Subject: SEAT BELT RETAINER BREAKS	Bulletin No: 08-001/08
	Last Issued: 1/4/2008

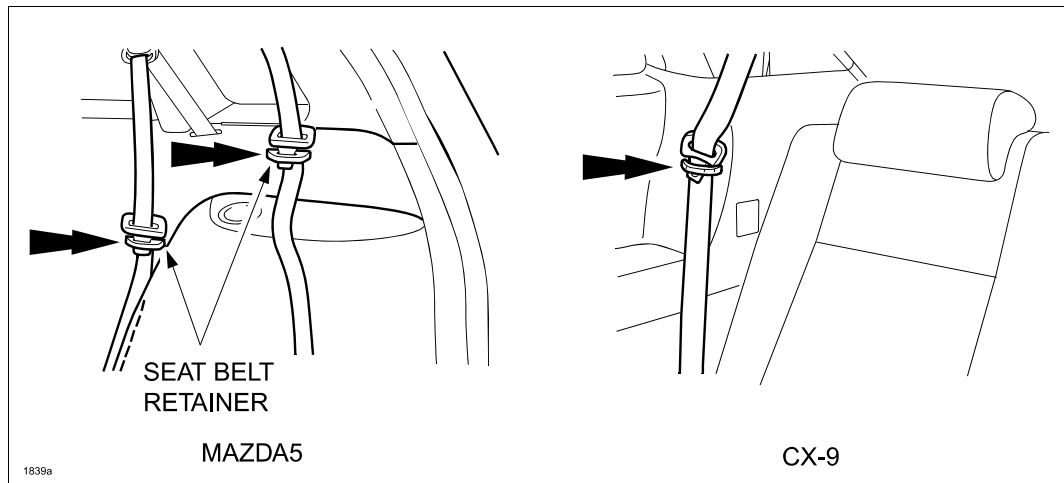
Some customer may complain that seat belt retainer clips for 2nd (Mazda5) or 3rd (CX-9, Mazda5) row seat are easily broken off. As a mass-production change, the construction of the seat belt retainer clip has been revised.

1. Verify customer concern.
2. Replace the broken seat belt clip with a modified one.

- The seat belt clip can only be installed in one direction.
